**SEDIMENT EVALUATION FOR THE
LOWER SYCAMORE CREEK DRAINAGE
IMPROVEMENTS PROJECT**

ADDENDUM TO
**SEDIMENT EVALUATION FOR THE
LOWER SYCAMORE CREEK DRAINAGE
IMPROVEMENTS PROJECT**

January 3, 2011

This addendum has been prepared after review of comments from the Development Application Review Team (DART) dated August 14, 2010. Based on these comments and long-term funding expectations, additional explanation and changes to the Sedimentation Evaluation for the Lower Sycamore Creek Improvements Project have been made. This addendum addresses those items.

Figure A - Revised Channel Cross Section

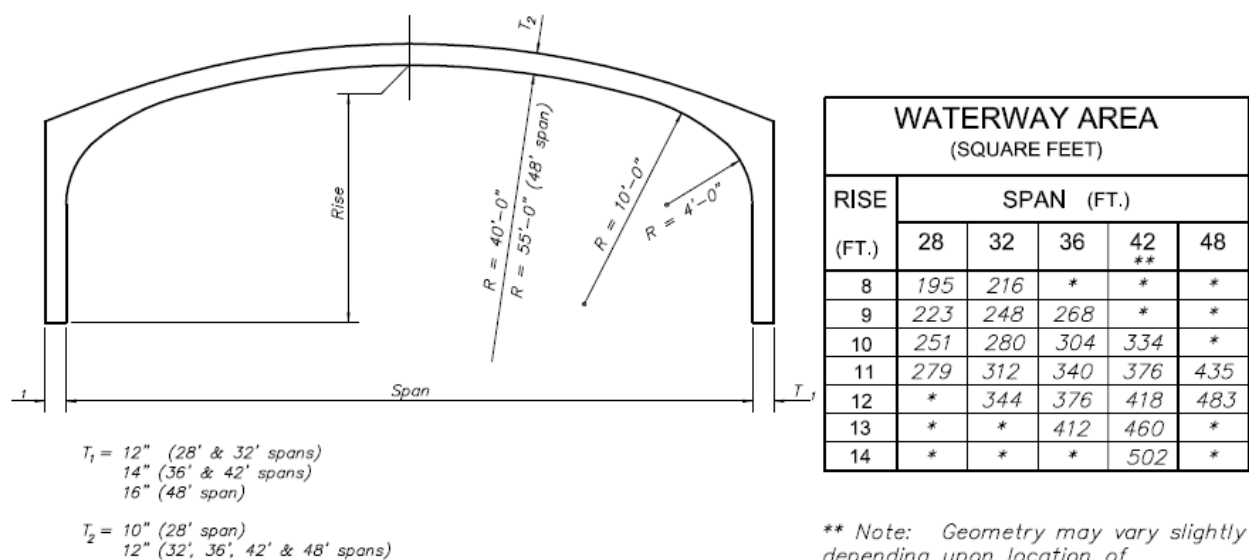
In response to DART comments, the channel section has been modified to more closely reflect Santa Barbara County Flood Control maintenance operations. The bottom width is revised from 28 feet to 20 feet by inserting a variable wedge of soil between the top of the proposed rock rip-rap toe protection and the new toe location (10 feet from the center of the channel). See Figure A.

The modification of the channel section has very minor impact on the sediment transport findings in the Sediment Evaluation, increasing the average velocity during channel forming flows by about 0.5 feet per second. The increase average velocity will slightly increase the sediment transport capability.
